ADDENDUM No. 2

RFP No. 22-82

S. Main Street Water Main Replacement and Resurfacing Project

DRAWING No. 2020-038-33
SHEET No. 33 OF 80

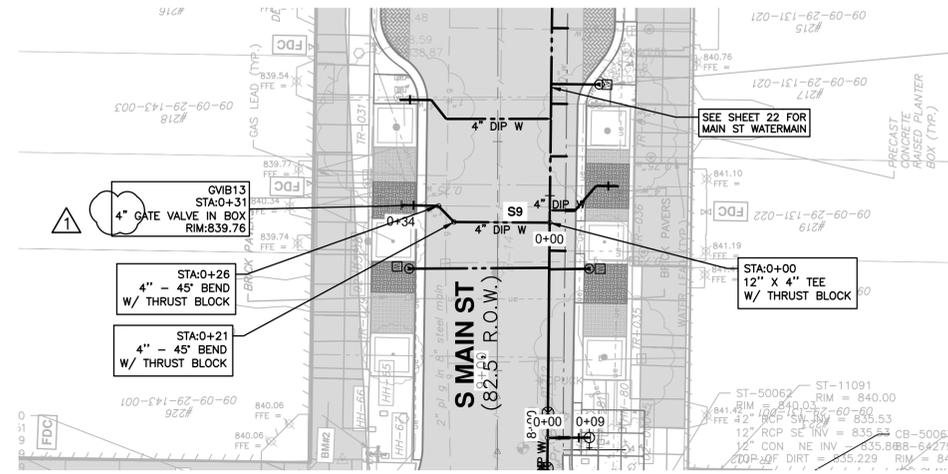
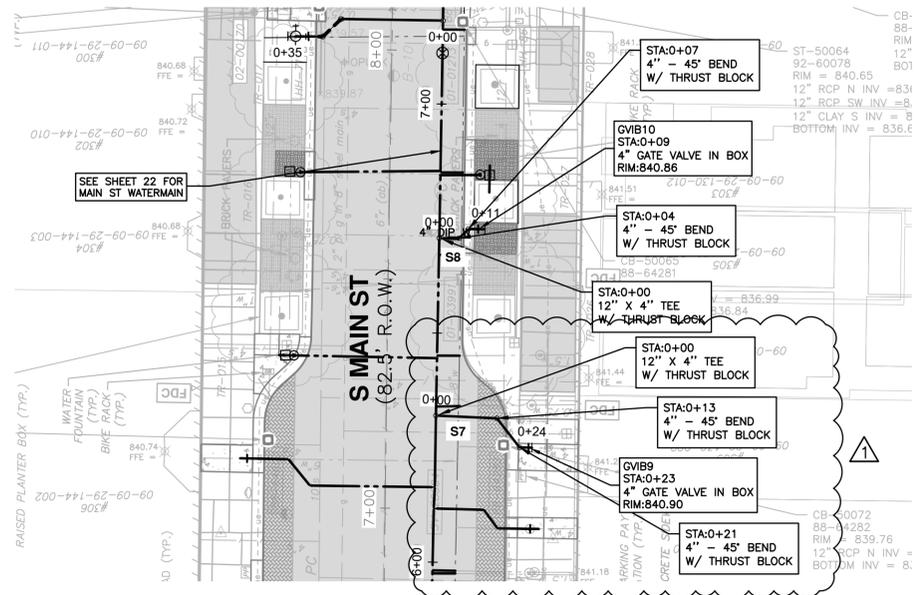
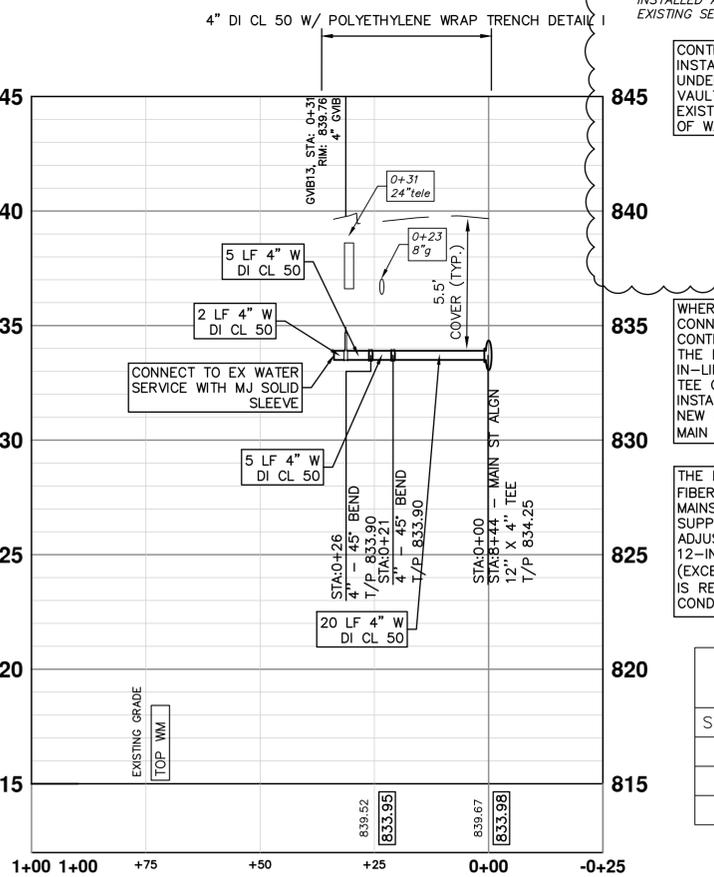
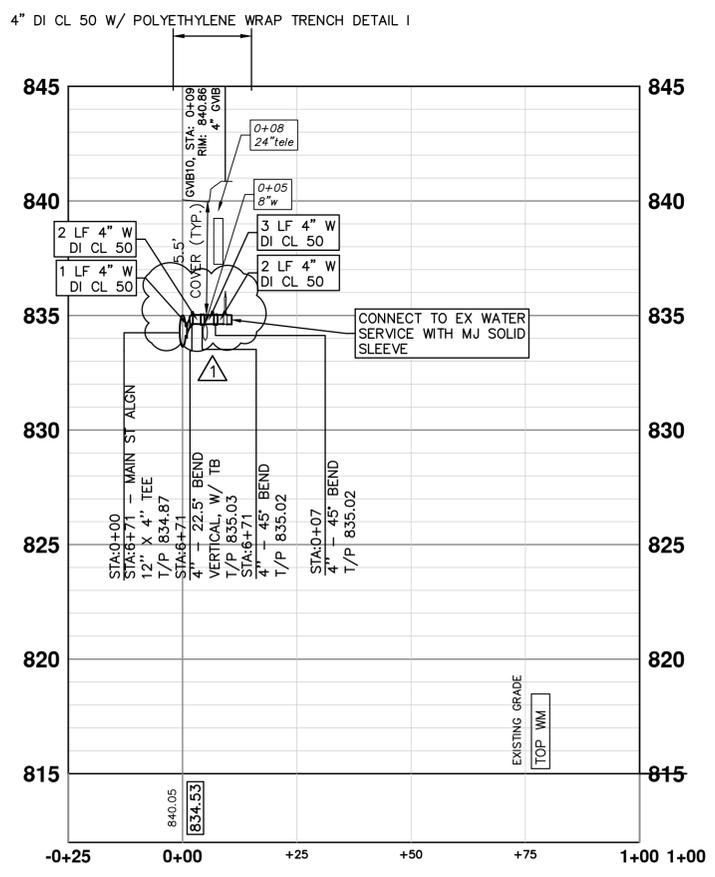
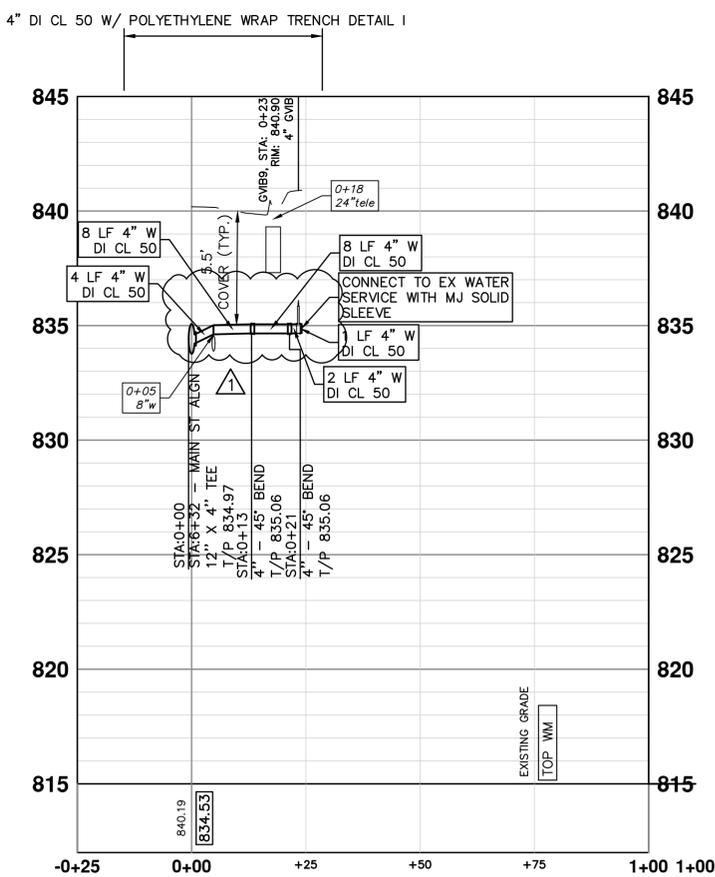
- Plan Sheet 32
- S1 lowering from STA 0+16 to STA 0+34 was eliminated.
 - S3 lowering from STA 0+00 to STA 0+09 was eliminated
- Plan Sheet 33
- S5 lowering from STA 0+00 to STA 0+09 was eliminated

SHEET No. 34 OF 80

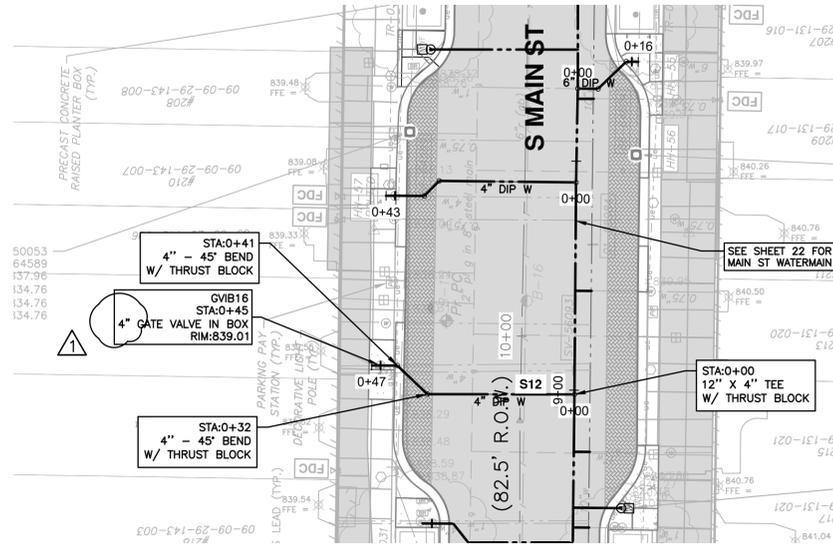
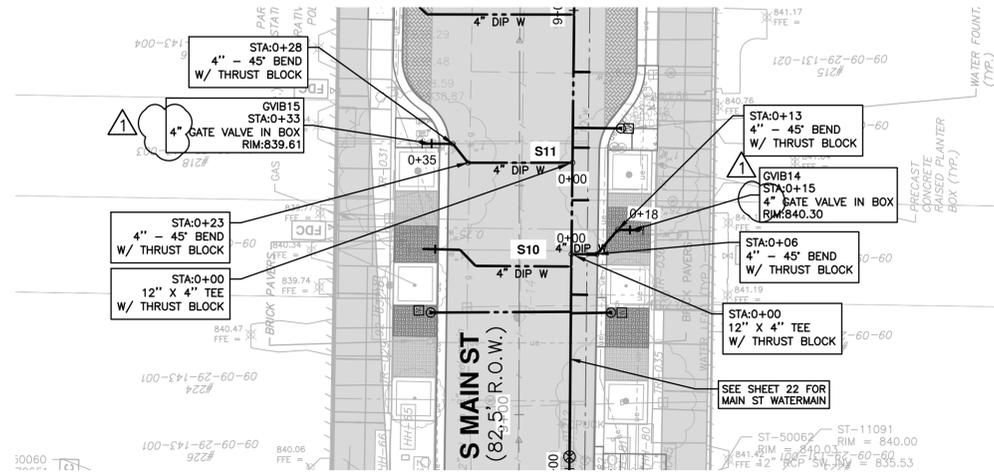
- Plan Sheet 34
- S7 alignment was horizontally shifted for ease of constructability
 - S7 lowering from STA 0+00 to STA 0+07 was eliminated
 - S8 vertical alignment was shifted to avoid existing watermain crossing. Note that the exact elevation of the existing water main crossing must be verified by the contractor. Existing water main will remain live throughout installation of new watermain.

S10: 219 MAIN ST

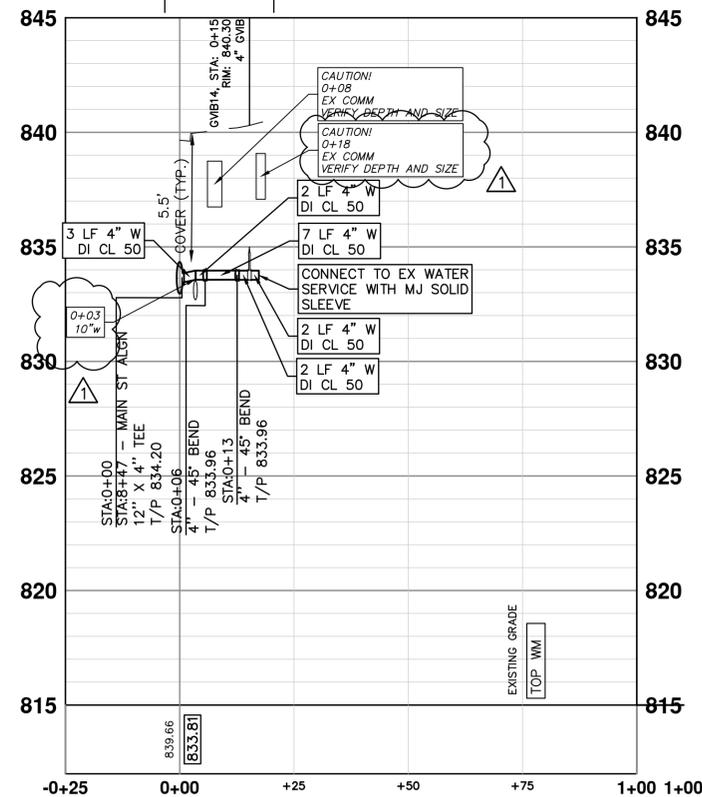
- Plan Sheet 35
- Utility crossings corrected at S10. Note that the exact elevation of the existing utility crossings must be verified by the contractor. Existing water main will remain live throughout installation of new watermain.

SHEET NO. 36 OF 80

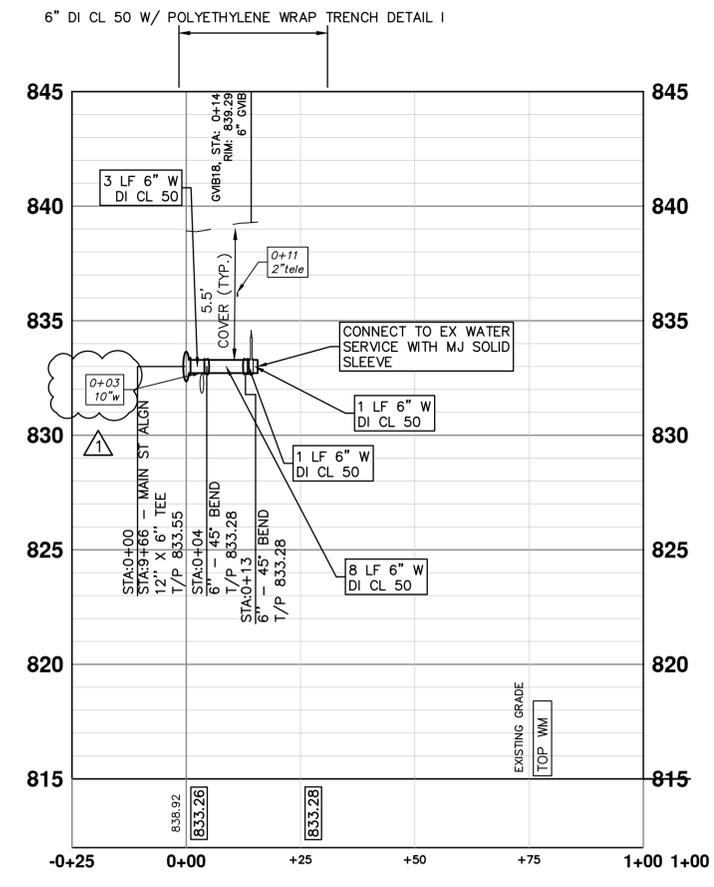
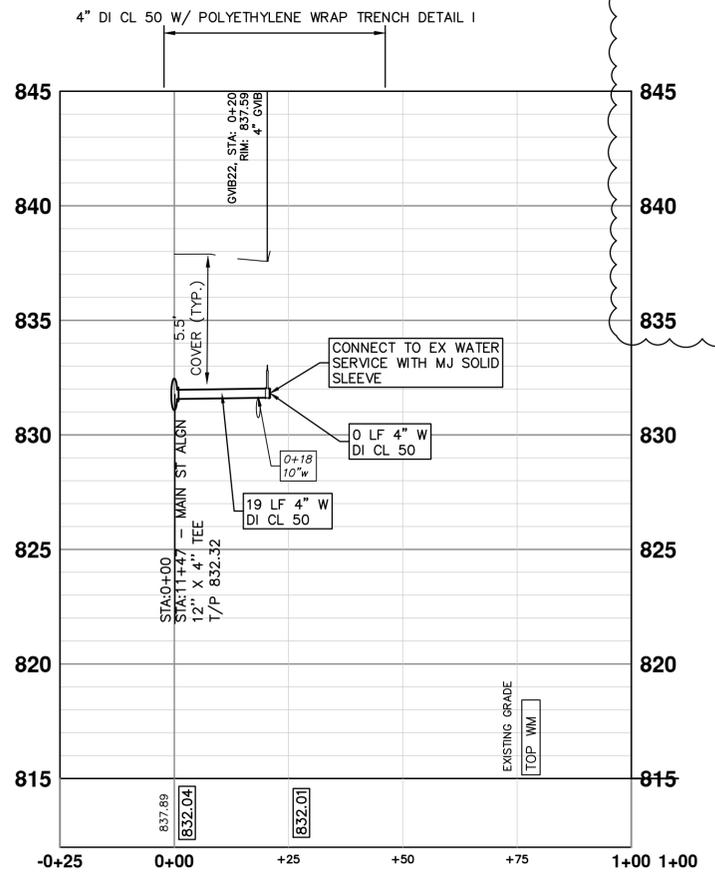
- Plan Sheet 36
- S14 and S15 were shifted horizontally for ease of constructability
 - S14: Elevation of existing watermain crossing was corrected. Note that the exact elevation of the existing water main crossing must be verified by the contractor. Existing water main will remain live throughout installation of new watermain.

S21: 101 (NORTH) MAIN ST

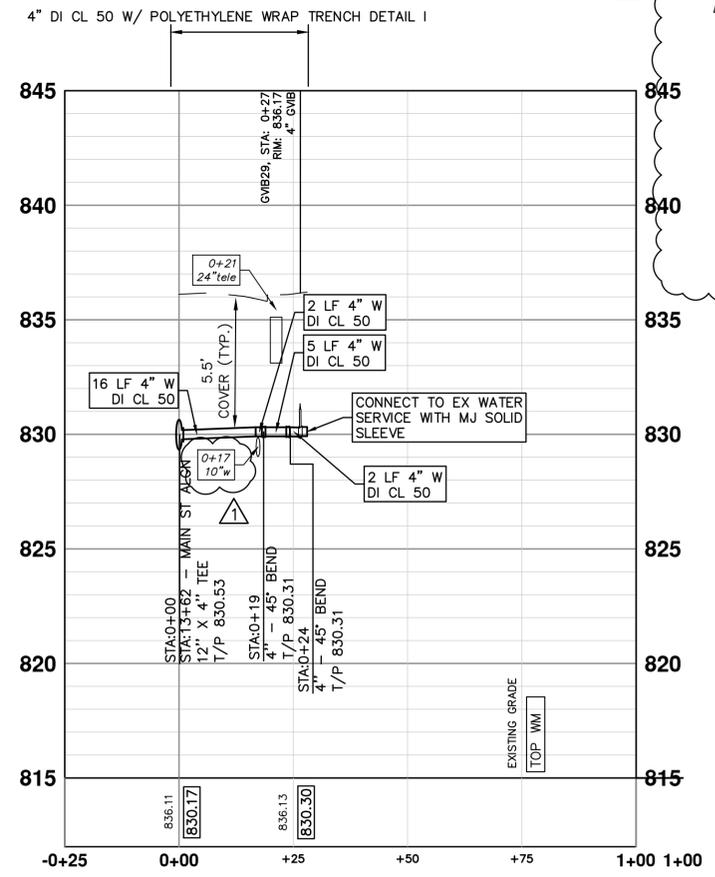
- Plan Sheet 38
- S21: Elevation of existing watermain crossing was corrected. Note that the exact elevation of the existing water main crossing must be verified by the contractor. Existing water main will remain live throughout installation of new watermain.
